Ground Water Review Form:

Application: T-11147

Applicant Name: Sunrise Water Authority

Figure 1. Well Location Map

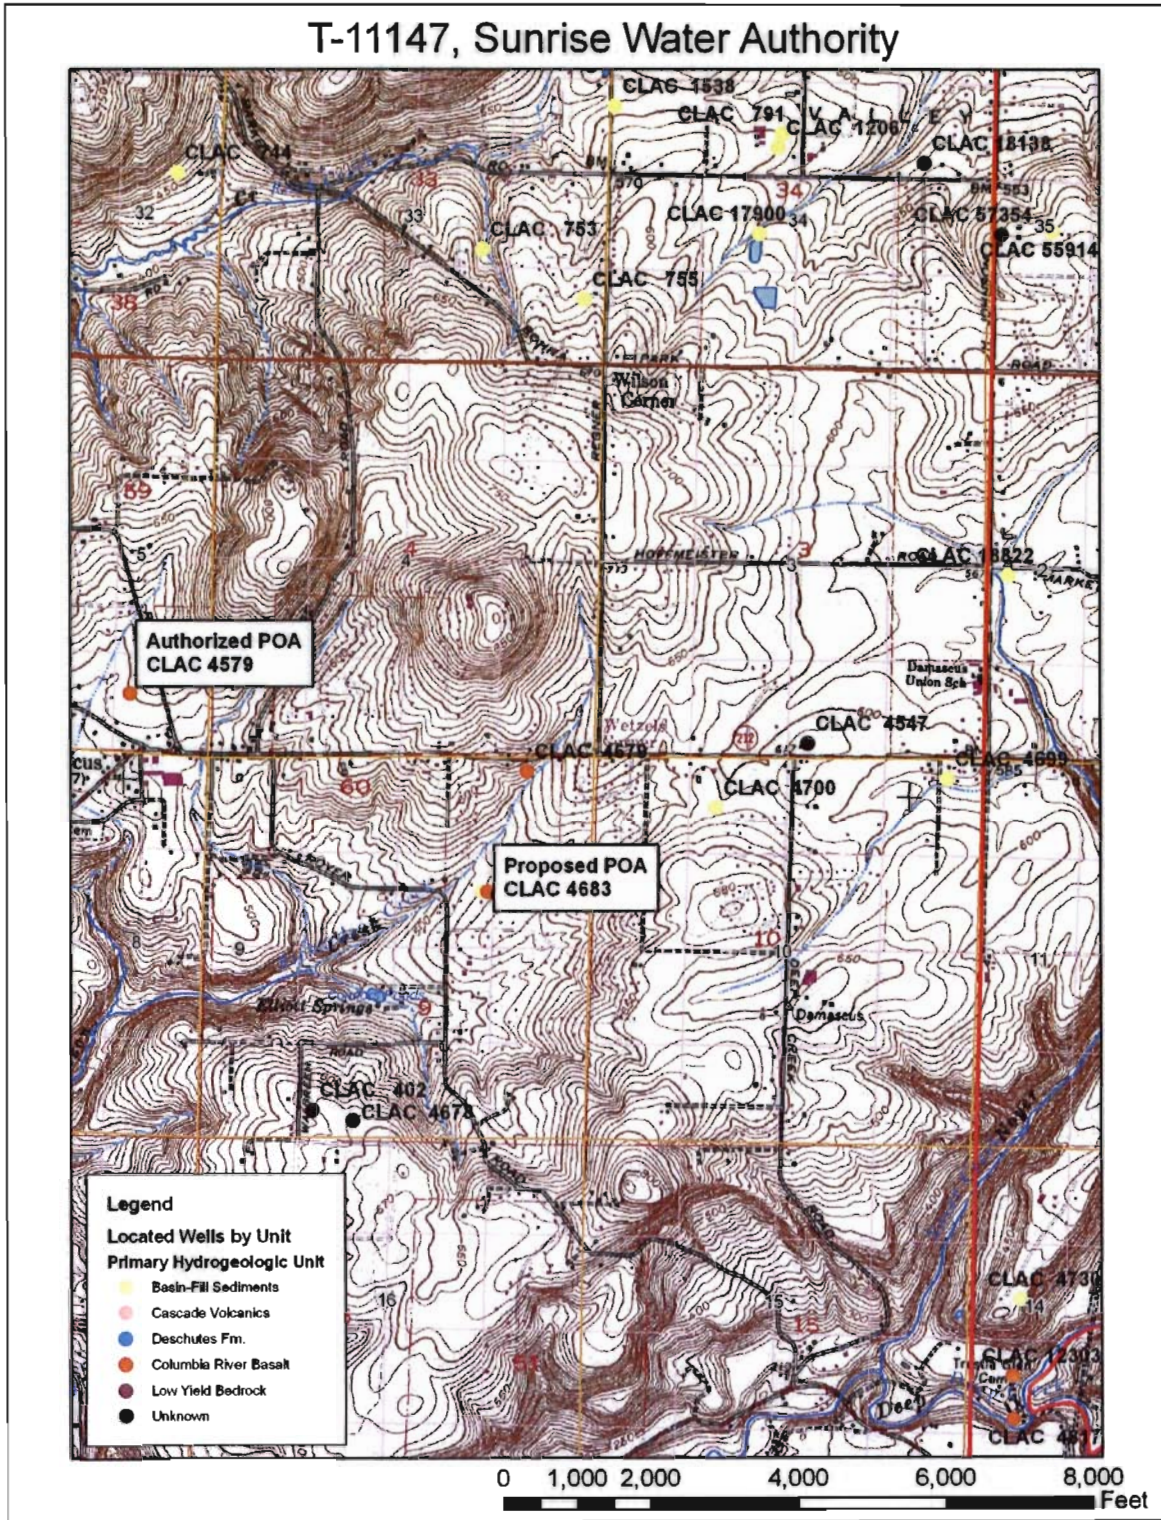
1. Basic description of the changes proposed in this transfer: This application proposes a change in POA to certificate 43436. CLAC 4579 (Sunrise Water Authority Well 1E) is the authorized well on the certificate. The proposed new POA is CLAC 4683 (Sunrise Water Authority Well 6). Both the authorized and the proposed POAs are located within the Damascus Groundwater Limited Area. The proposed POA is located approximately 1 mile southeast of the authorized POA (Figure 1).

Figure 2. Static water level elevations in nearby alluvial wells.

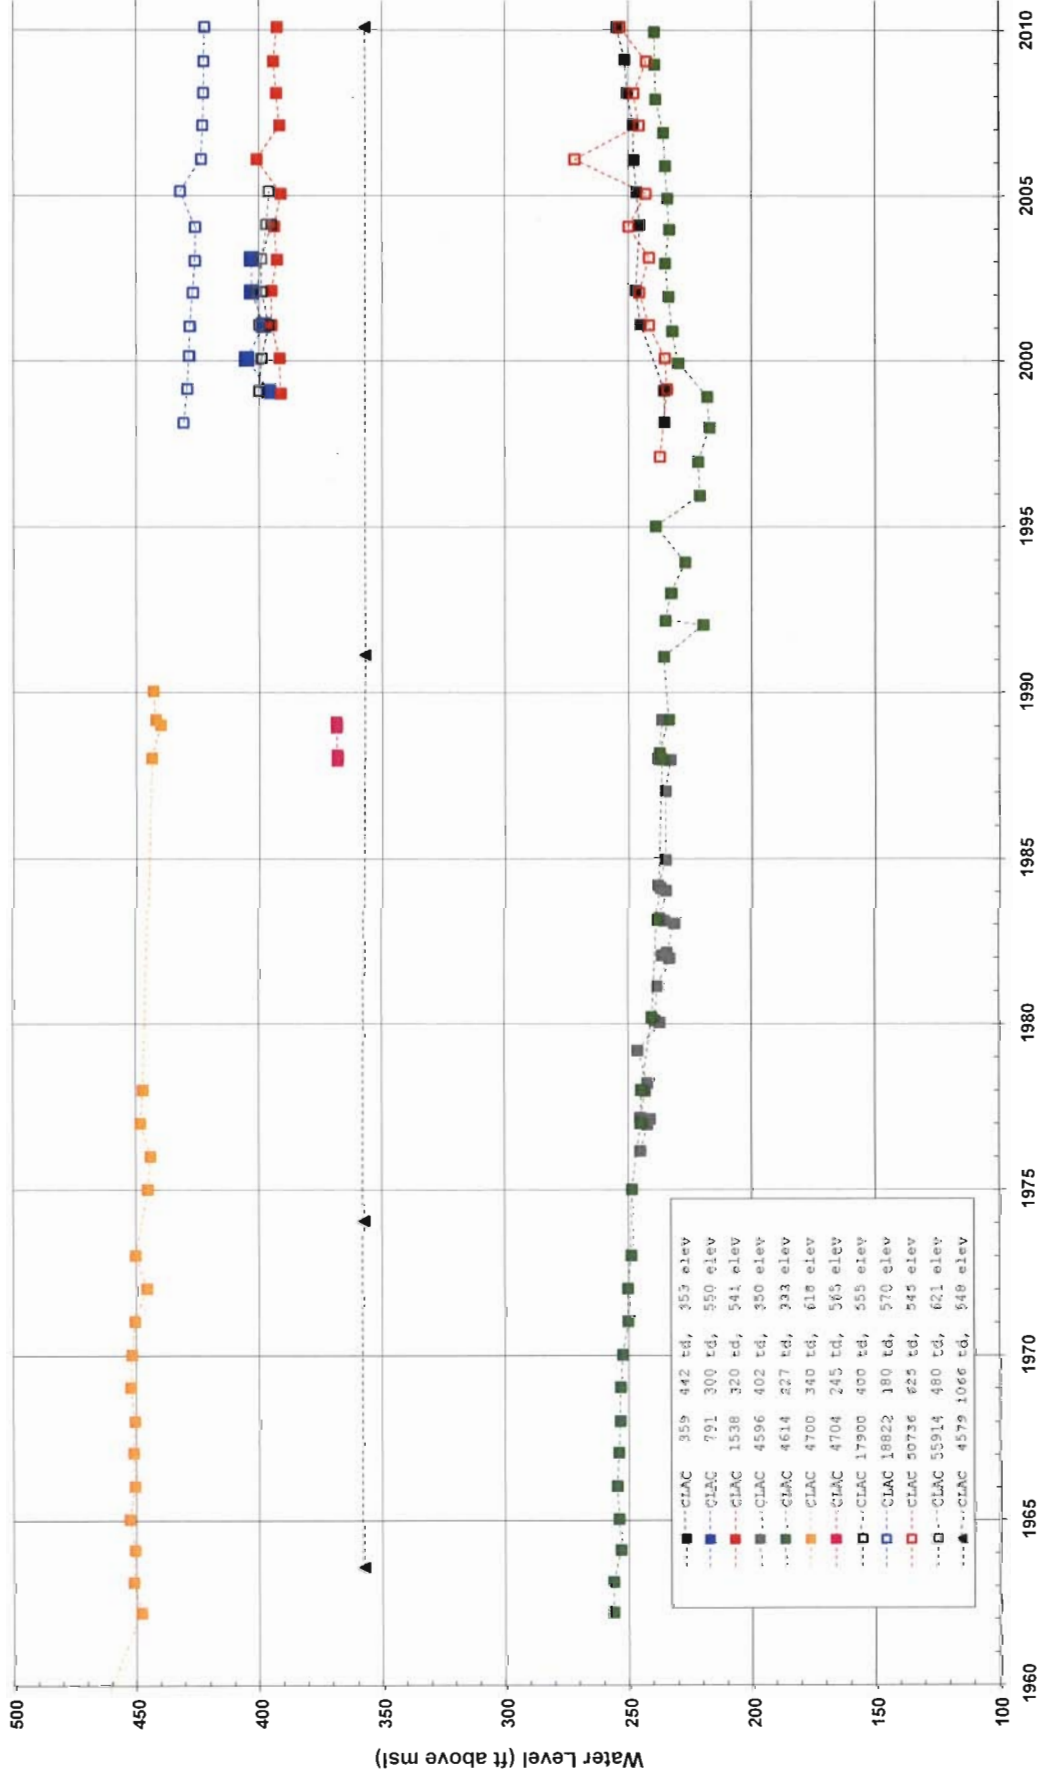
Static water level data suggest the wells do not develop the same aquifer; however, well construction issues complicate aquifer determinations. Hydraulic head data in the form of static water level measurements are commonly used to make aquifer determinations. Wells with similar static water levels are generally presumed to produce from the same aquifer. CLAC 4579 commingles the alluvial aquifer and the CRBG aquifer system, as such, the static water level elevation in CLAC 4579 (357 feet above mean sea level) is a composite head of both aquifers. Static water level elevations in nearby wells completed only in the alluvial aquifer range from approximately 240 feet to 420 feet above mean sea level (msl) (Figure 2), while static water level elevations in nearby basalt wells range from 70 to 120 feet above msl (Figure 3). The high static water level elevation in CLAC 4579 suggests that although the well is open to both the alluvial and basalt aquifers, it probably obtains most of its production from the alluvial aquifer.

b) If yes, estimate the portion of the right supplied by each of the sources and describe any limitations that will need to be placed on the proposed change (rate, duty, etc.): The hydraulic head in the authorized POA (CLAC 4579) is likely controlled by aquifer pressure in the alluvial aquifer, suggesting most of the production is from the alluvial aquifer. Estimating the portion of the water right supplied by each source comes with some uncertainty, however, considering the data presented above, a reasonable estimate for the portion of the right supplied by each source is 75% from the alluvial aquifer and 25% from the basalt aquifer system. If this transfer is approved, production should be limited to 25% of the maximum rate allowed on certificate 43436.
